Subject: Response to DMS comments on the Year 5 Monitoring Report Draft review for the Logan Creek Stream Restoration Project; Savannah River Basin - CU# 03060101; Jackson County, North Carolina; NCDMS Project # 92515; Contract No. D06046-A

Logan Creek Stream Restoration Project Year 5 Monitoring Report

**Jackson County, North Carolina
NCDMS Project ID Number – 92515**

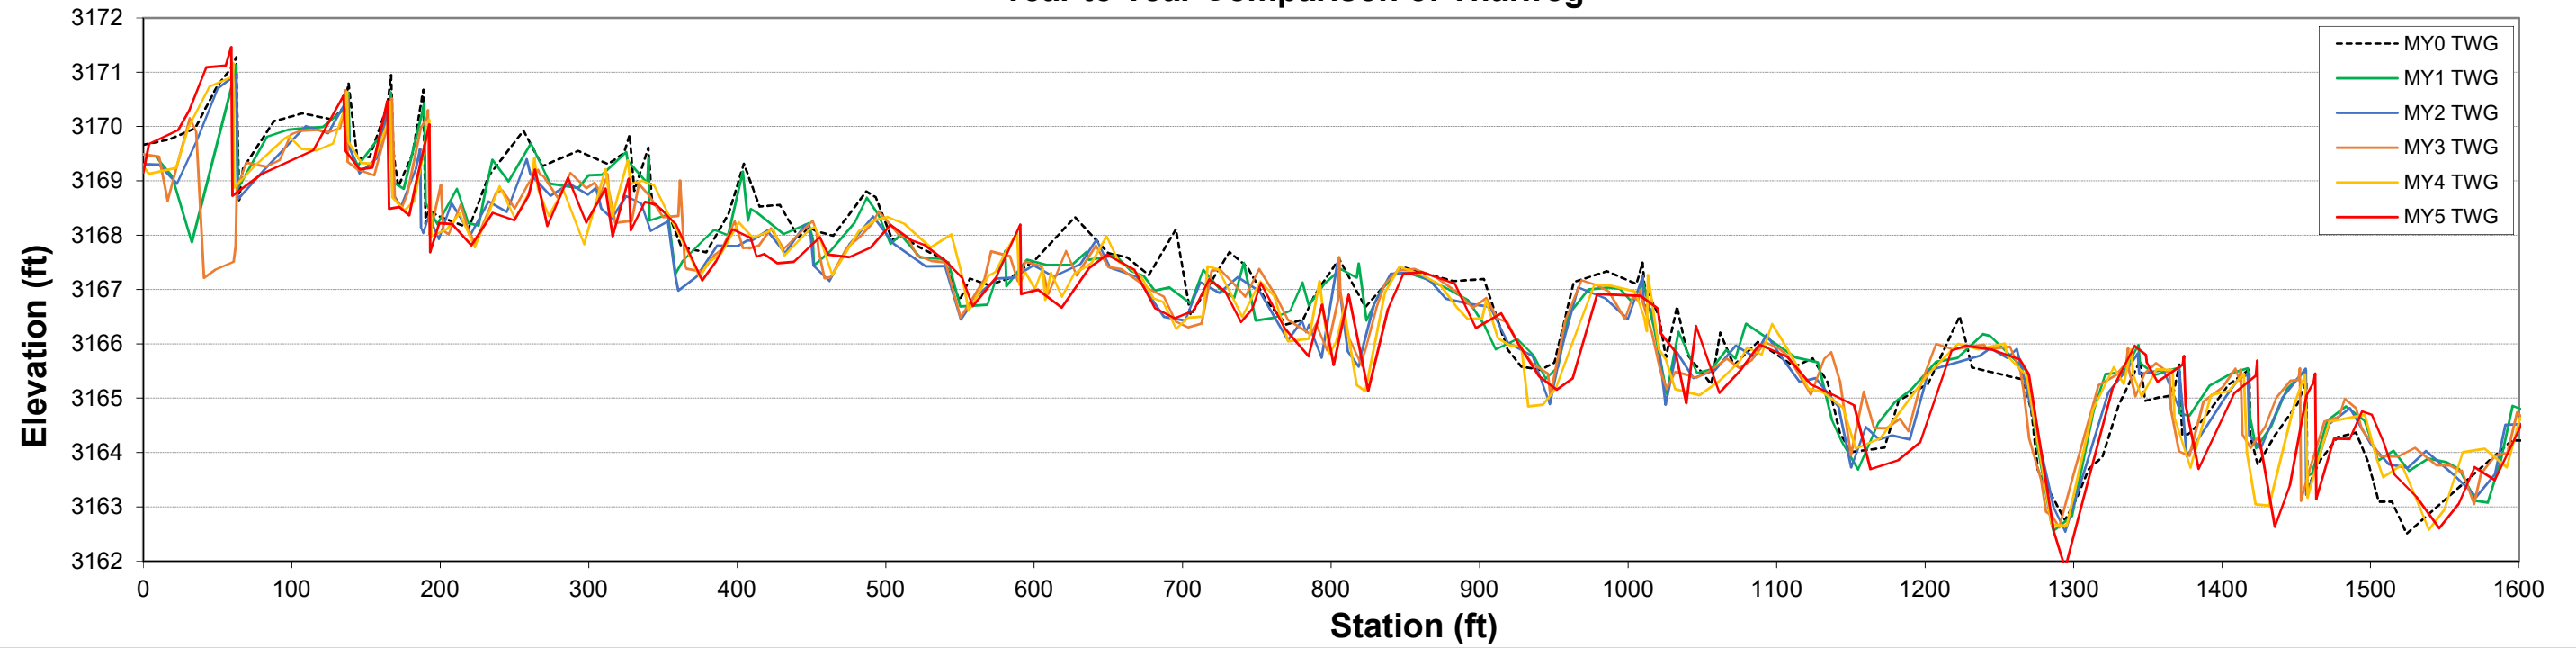
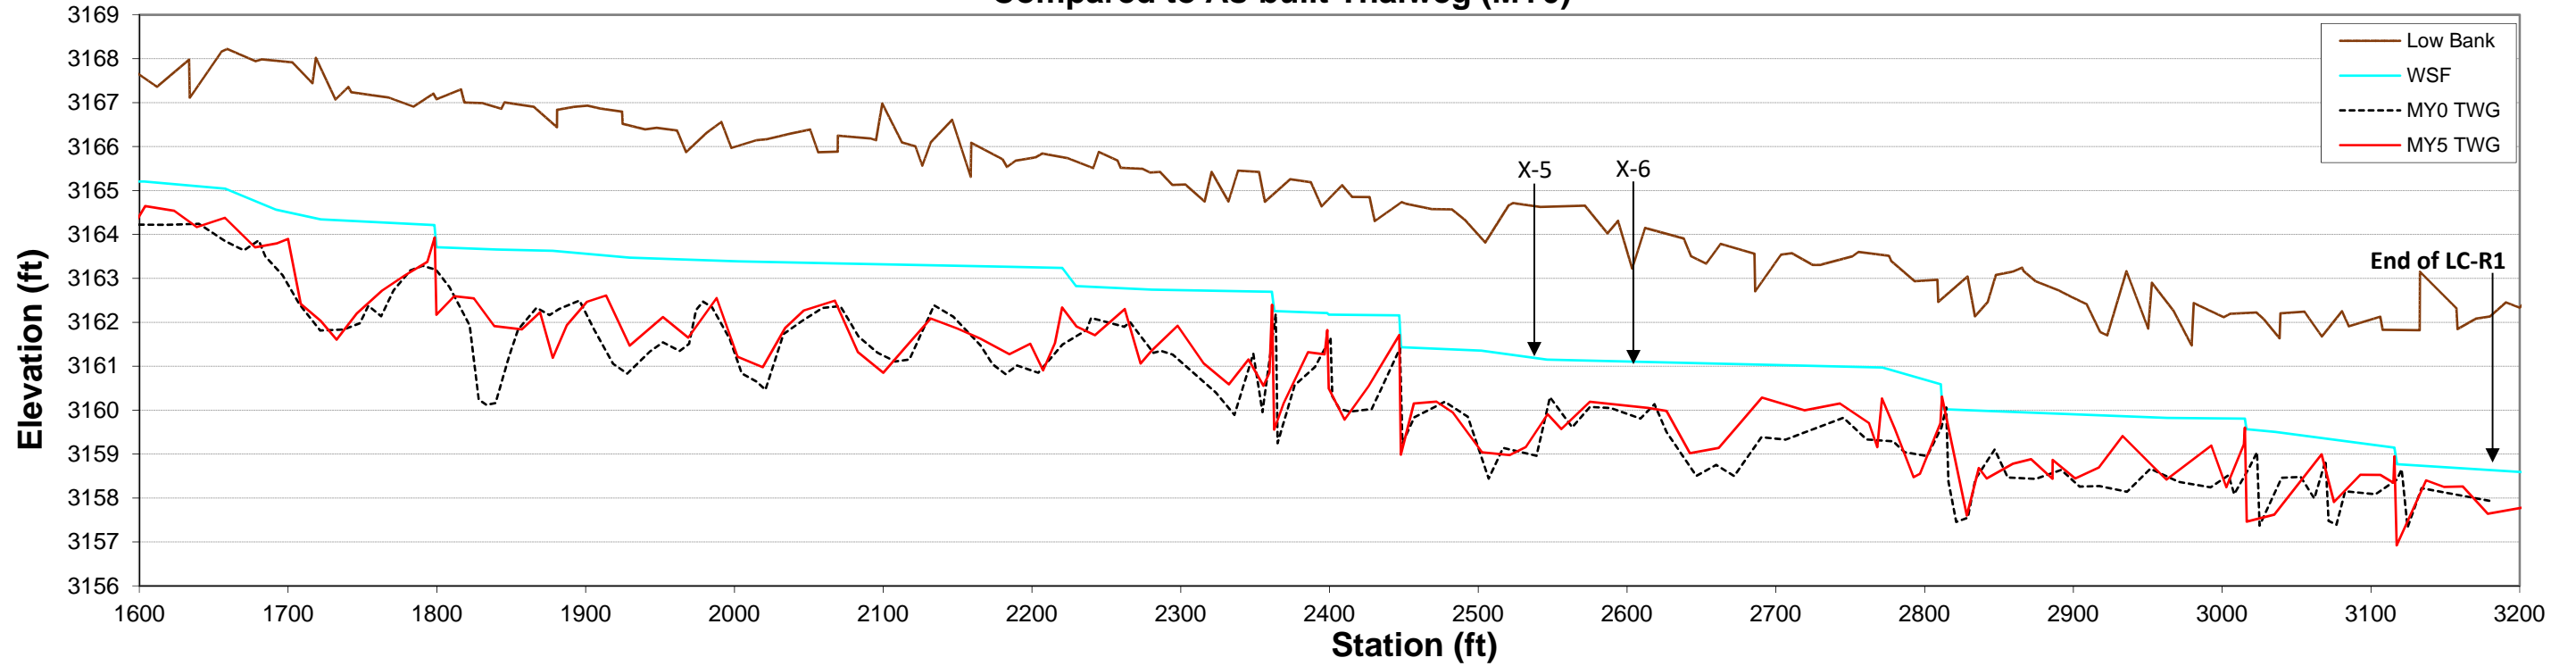
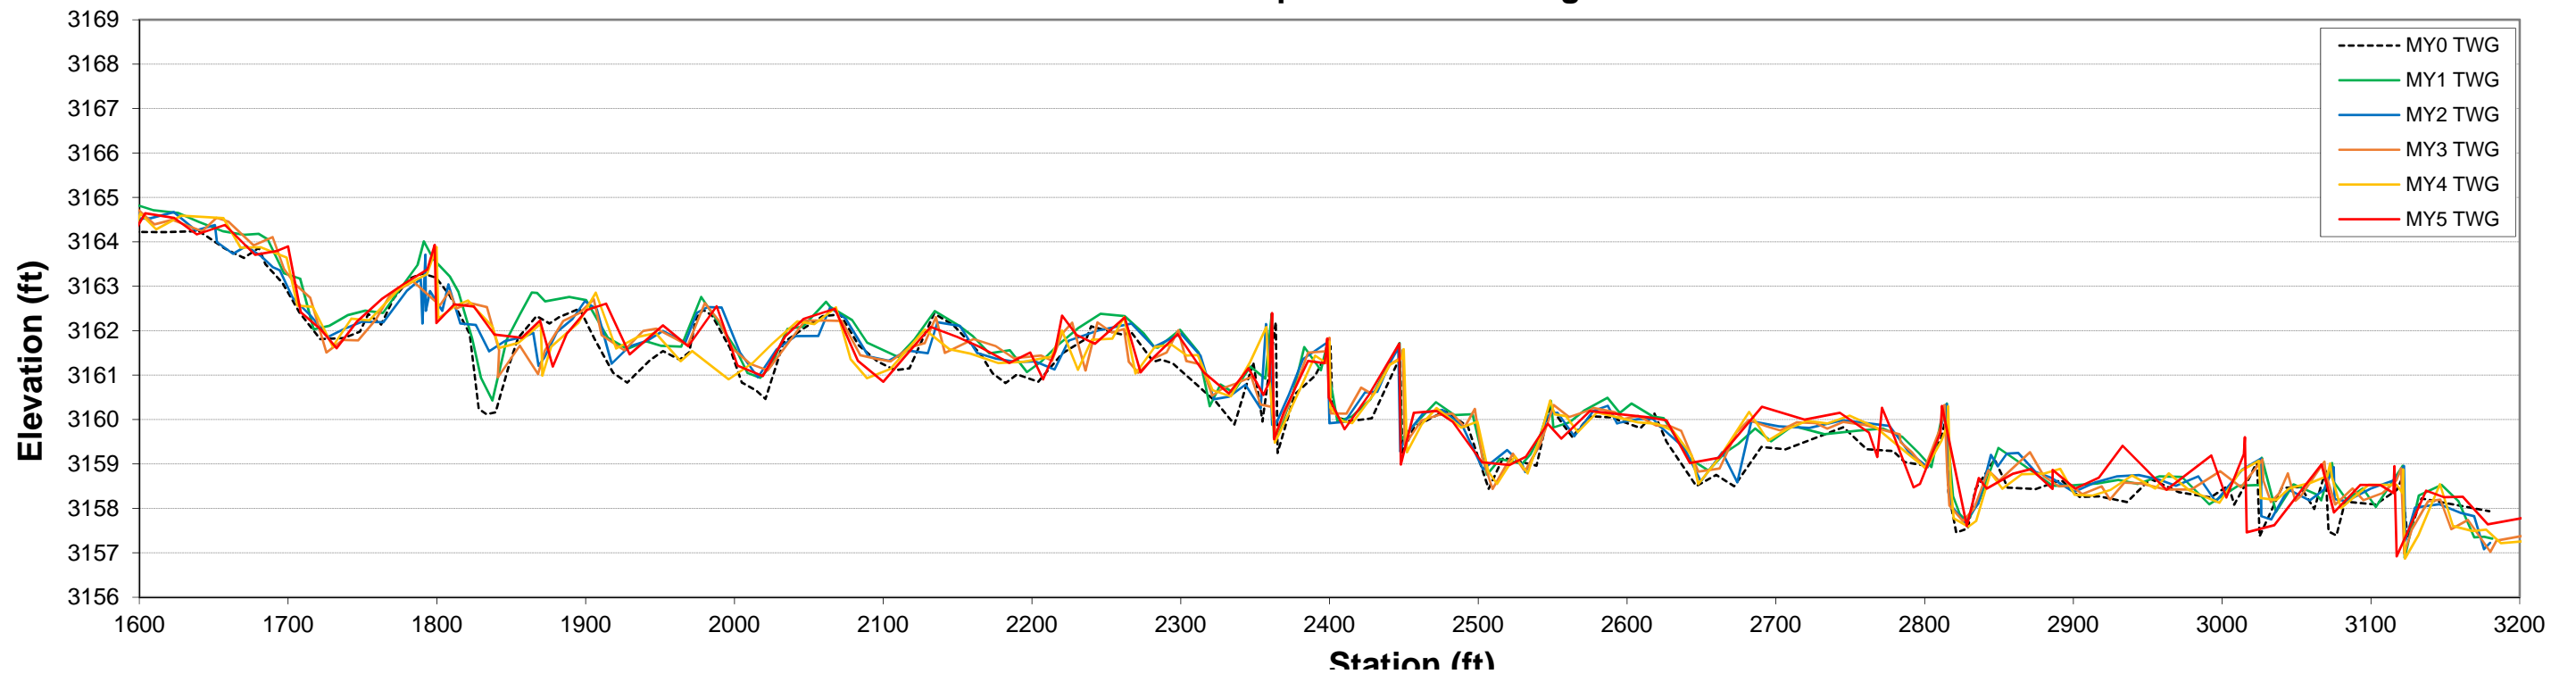
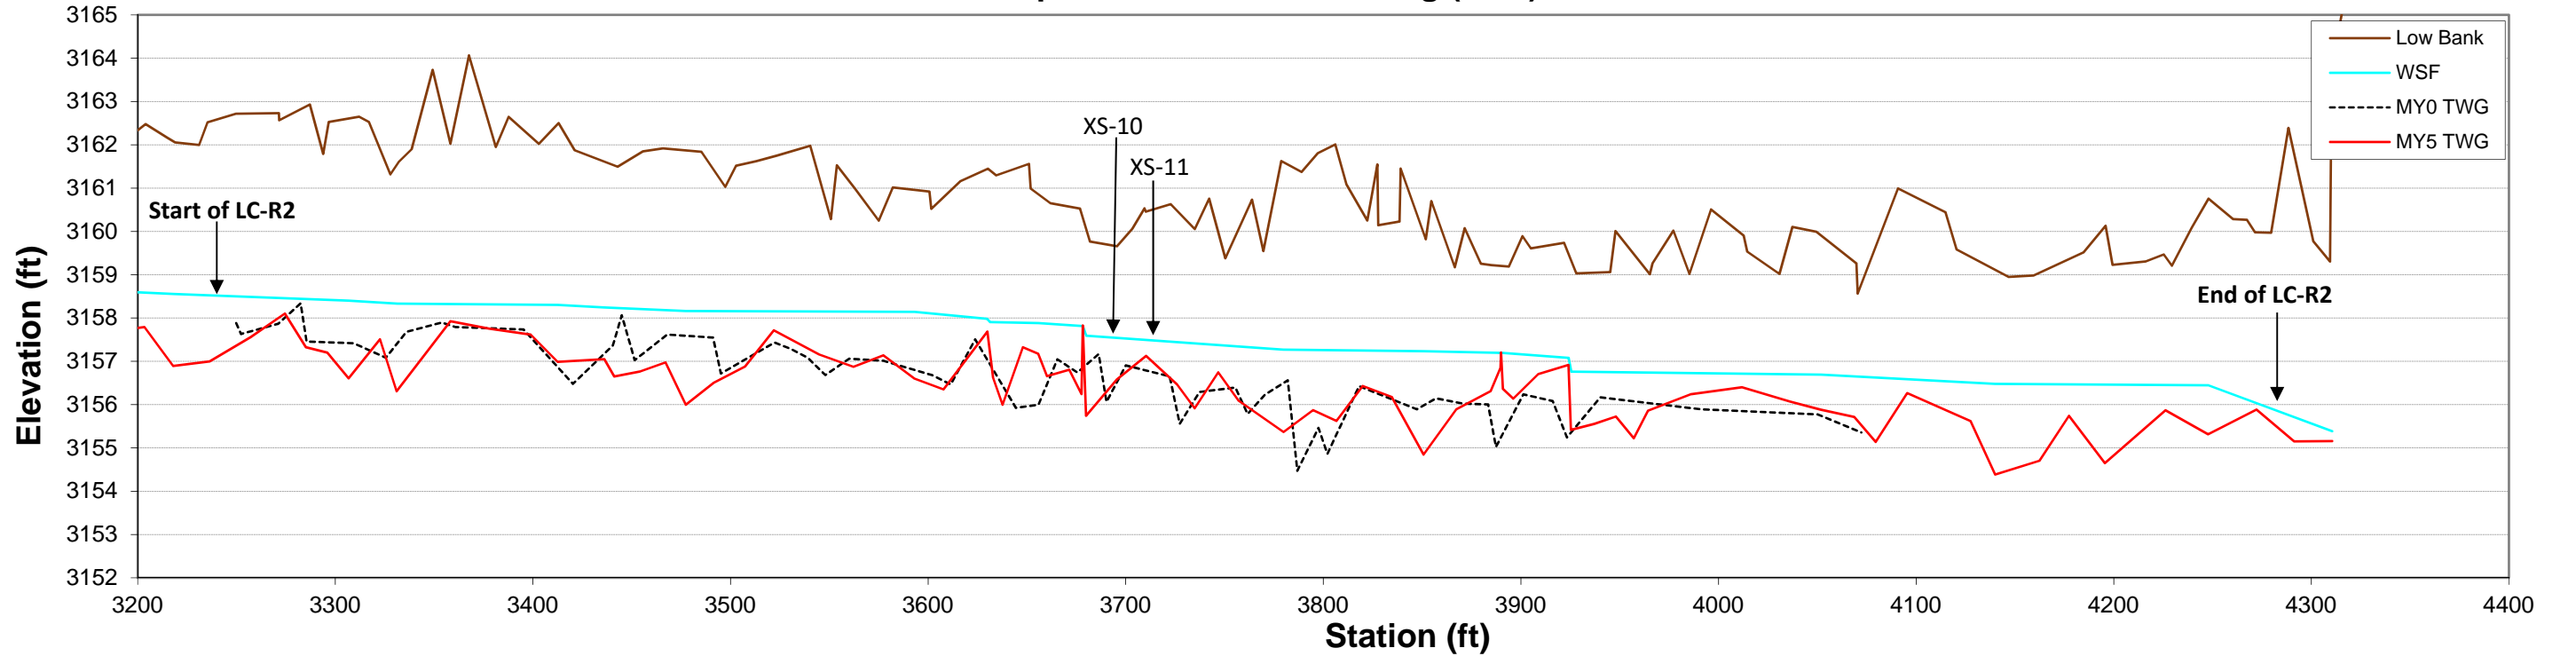
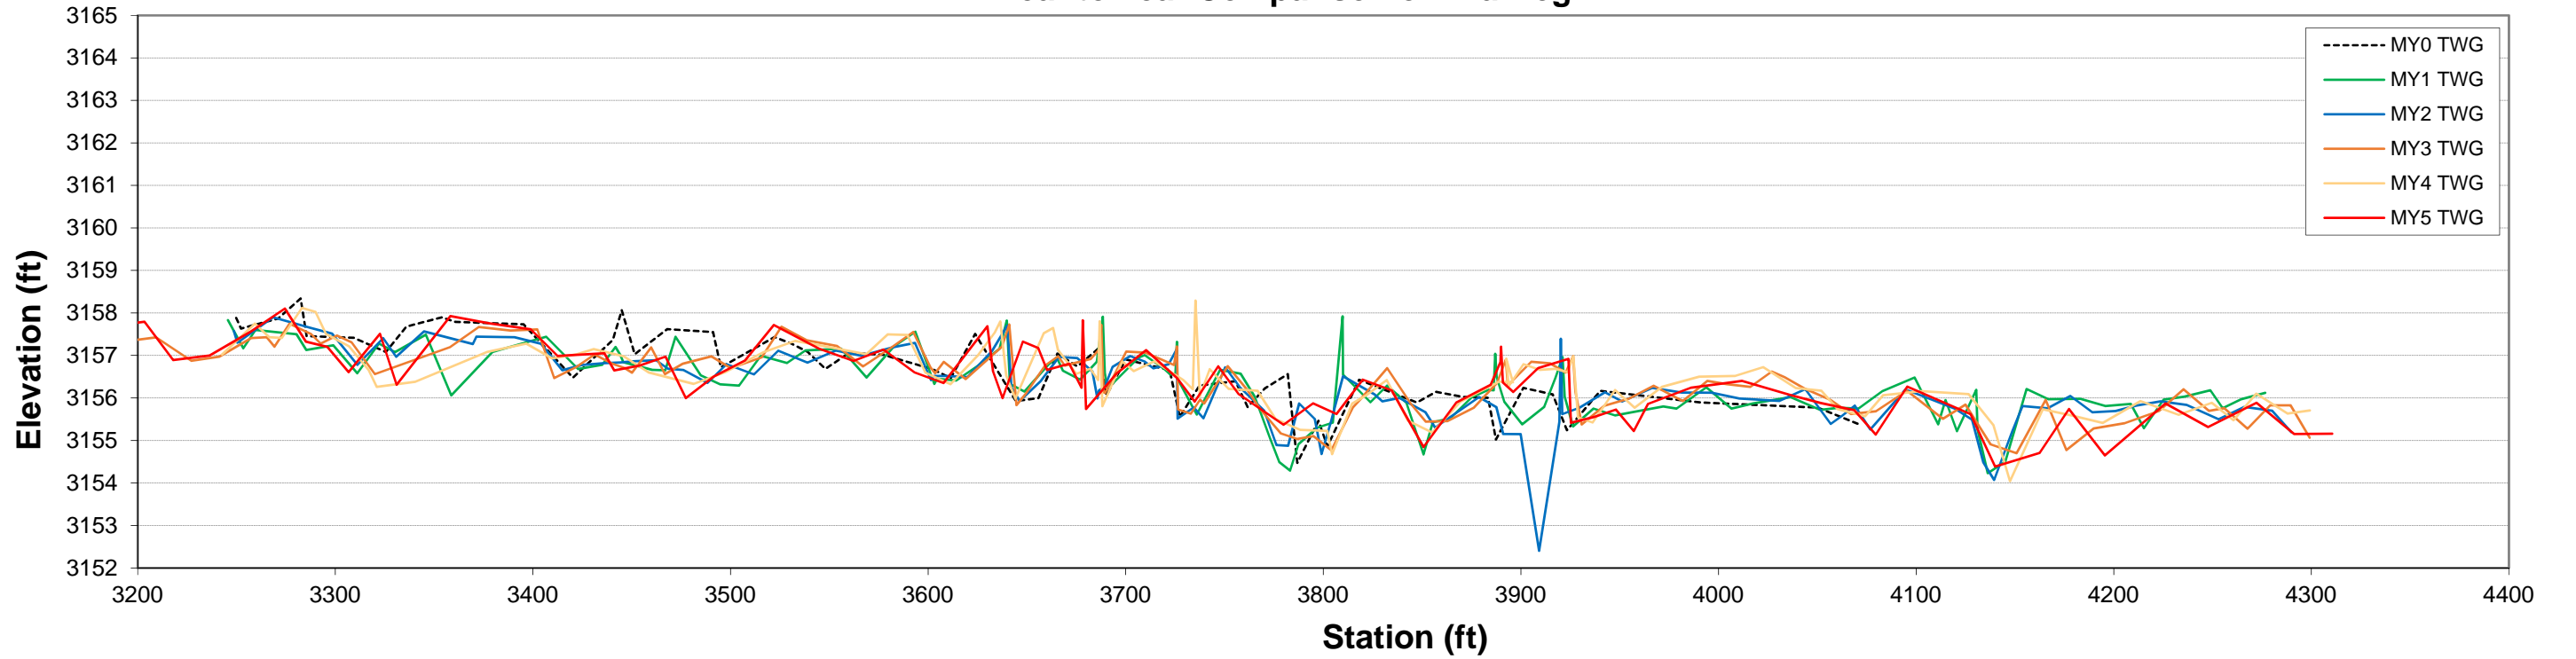
- **Table 9 – Verification of Bankfull or Greater than Bankfull Events:** DMS recommends adding a row for MY1 noting that no bankfull events were recorded in MY1.
A row for MY1 was added indicating do data was collected that year.
- **Profile of UT8:** The longitudinal profile just shows profile data from MY1 and MY5. A footnote is missing from the graph. Please be consistent with the other graphs. DMS recommends including the profile that shows MY1 compared to MY5 and a separate graph showing all longitudinal profile data collected for the reach over the monitoring term.
The UT8 profile was corrected so that both the MY1 to MY5 comparison and the profile showing the year to year comparison, are included. The footnote is also shown.
